Procurement Department
IFB: Conference Room Rehab for Admissions Relocation
SU-022626
Addendum #1 * July 13, 2026

Addendum 1

Re: SU-022626 Conference Room Rehab for Admissions

E-100.00

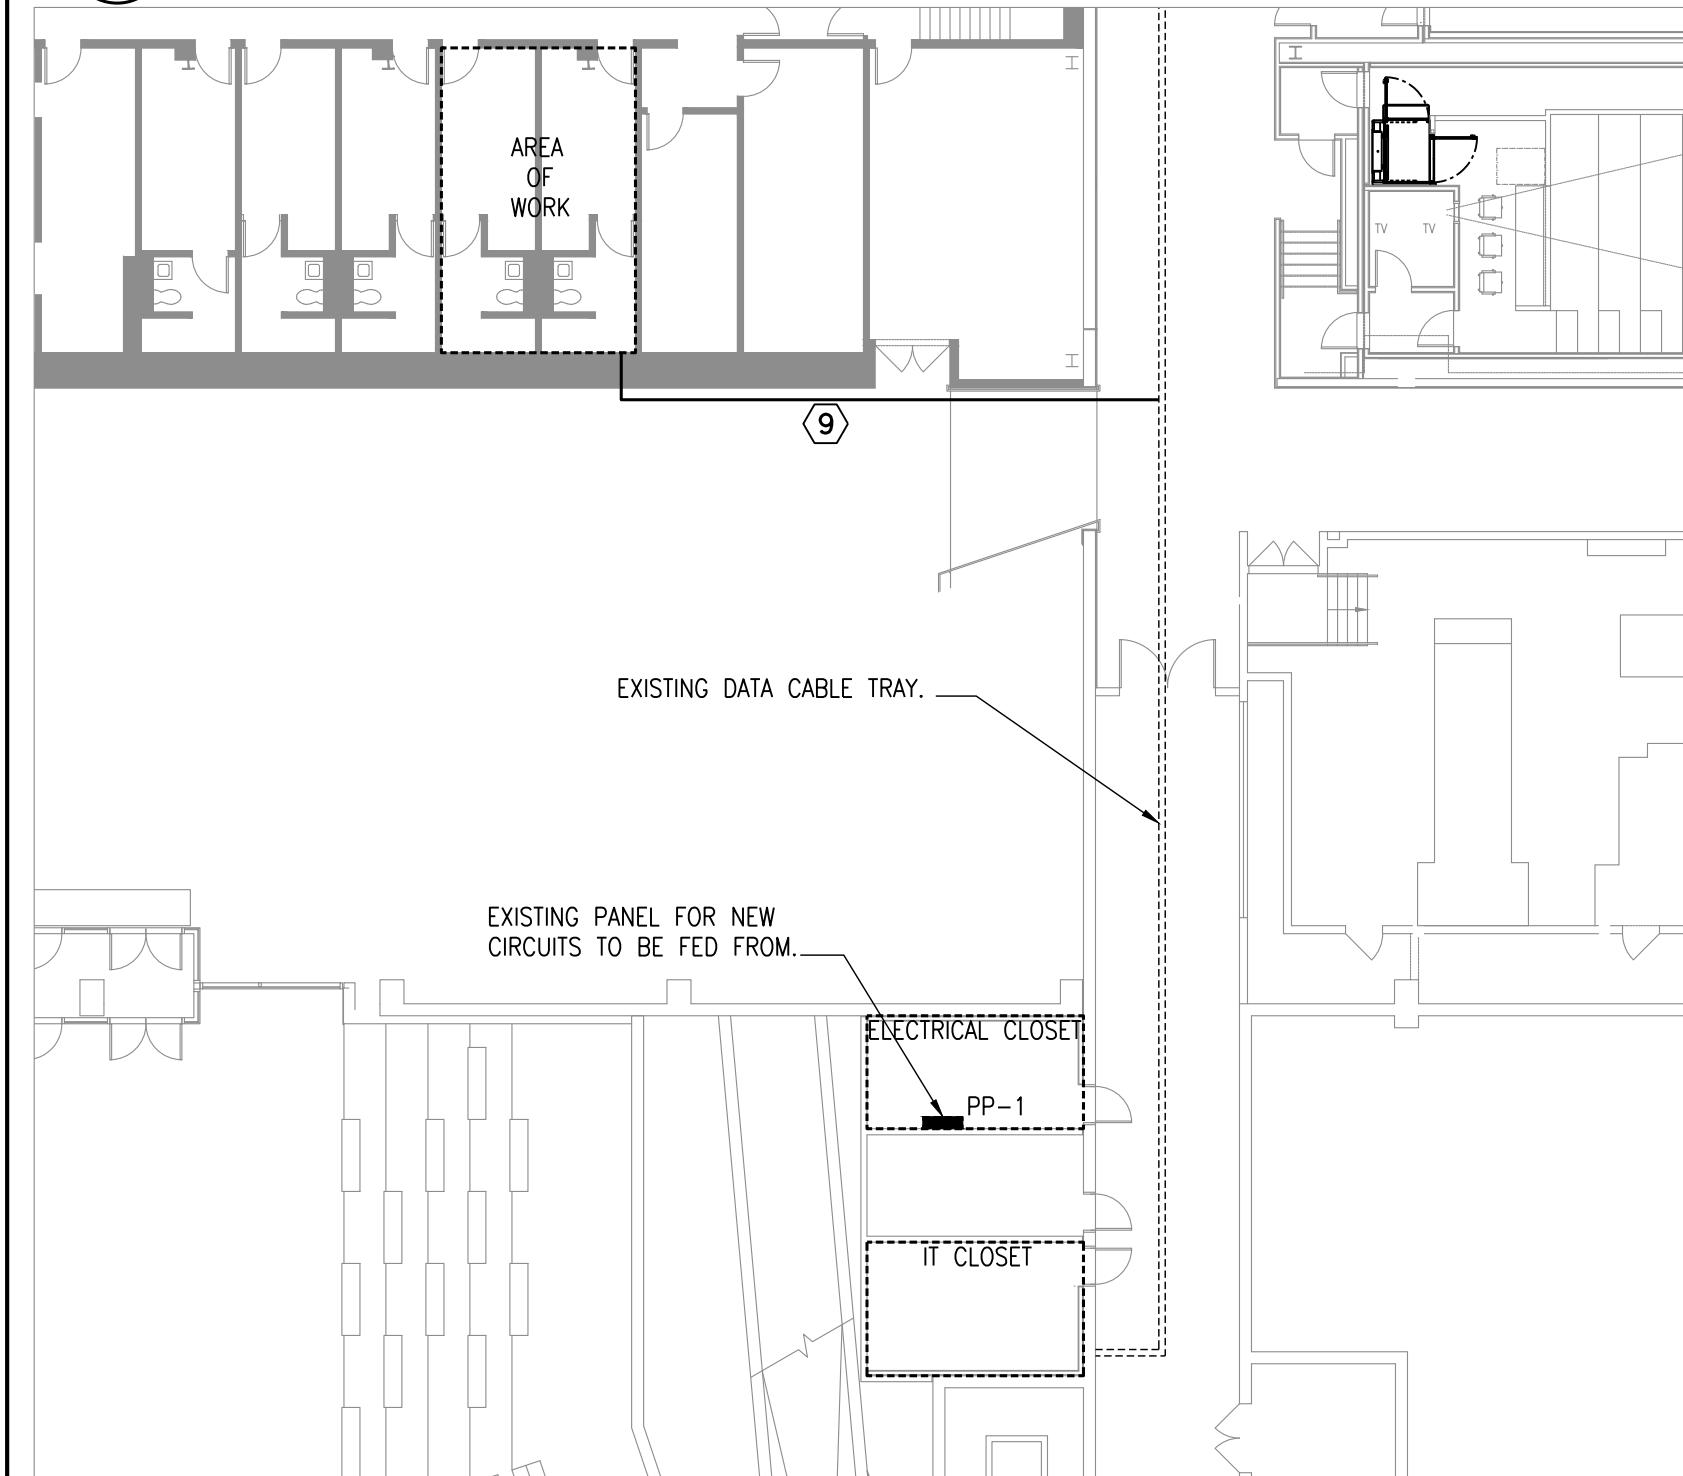
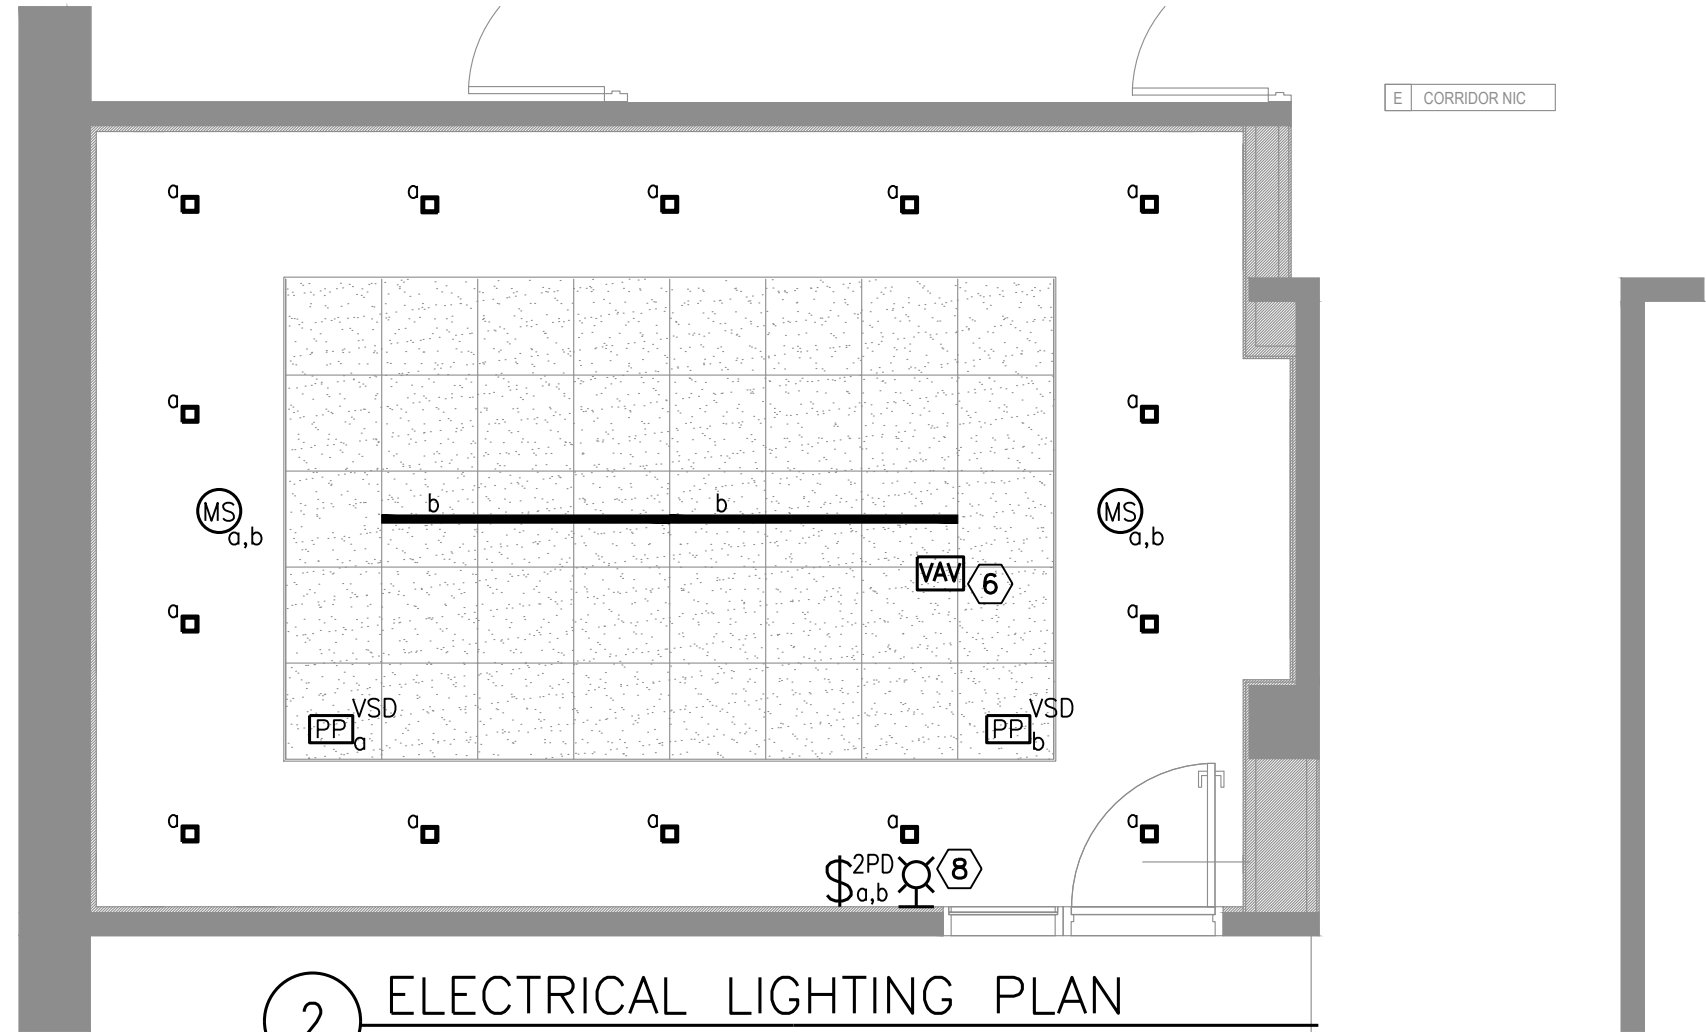
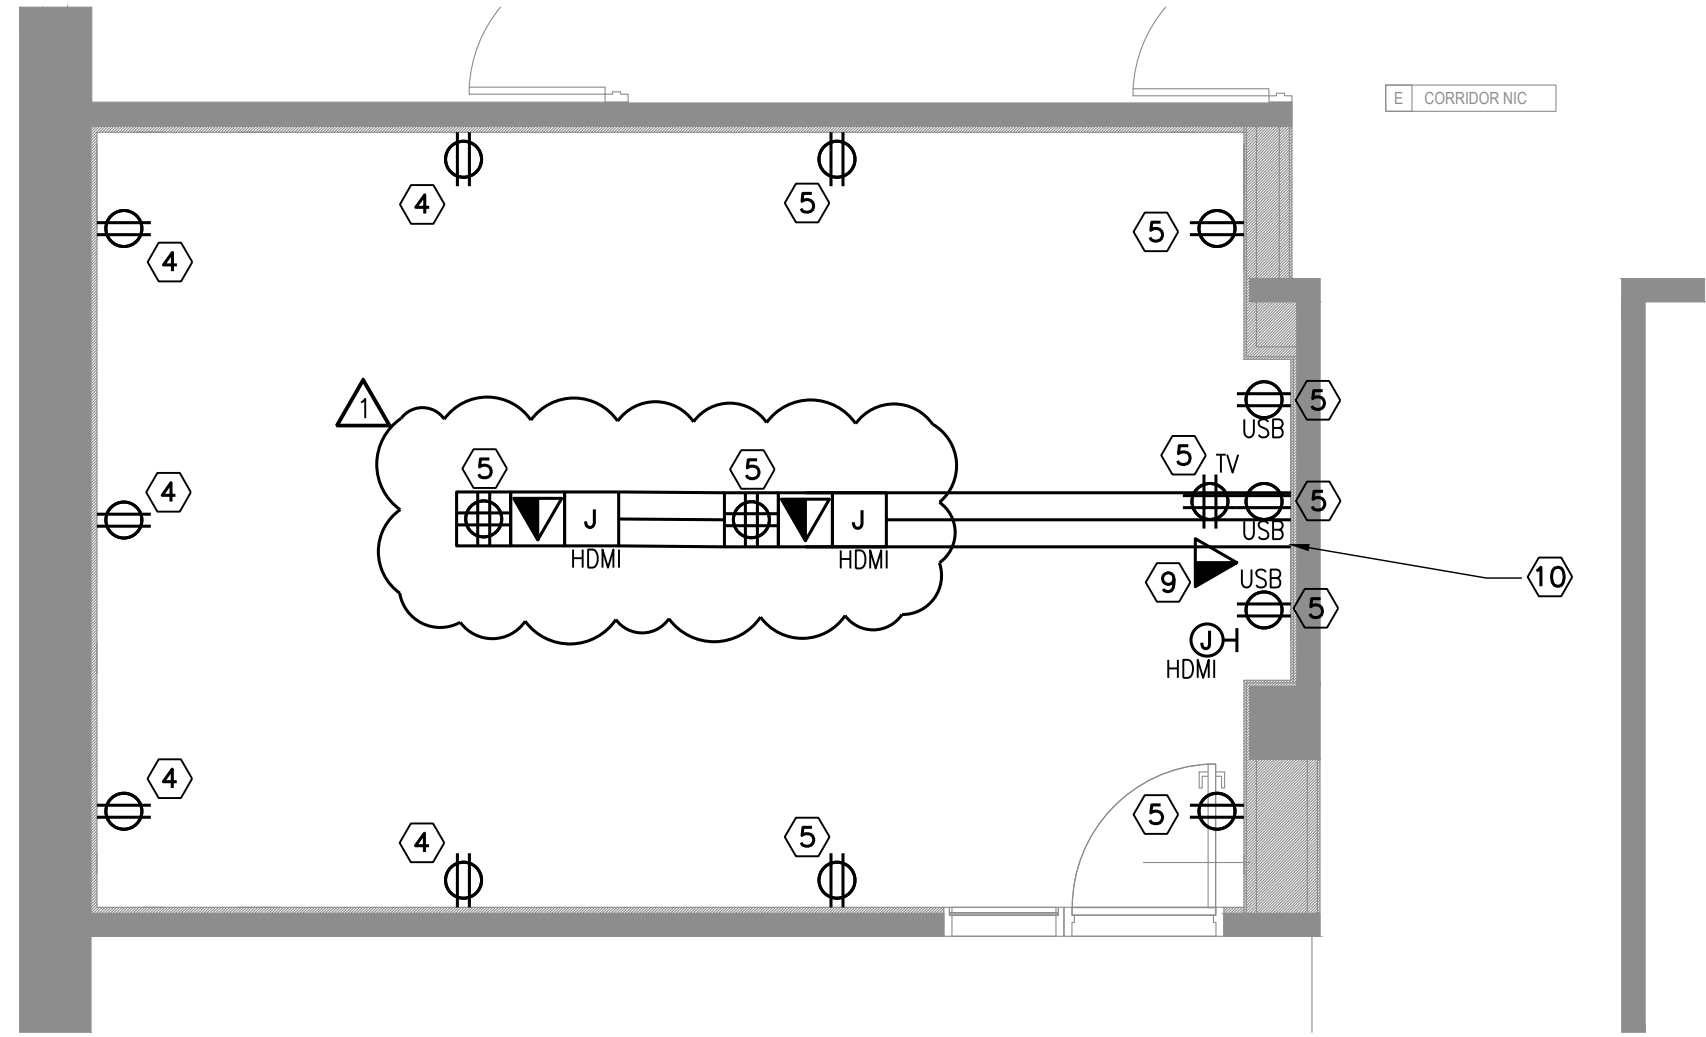
Question 1 The layout shown on dwgs. 2/G003, DM100, M100 & 4/E100 for the storage room adjacent to the work area does not match. Please clarify this discrepancy?

Answer 1 As per the consultant this is a minor discrepancy and is outside the scope of work and should not impact the project.
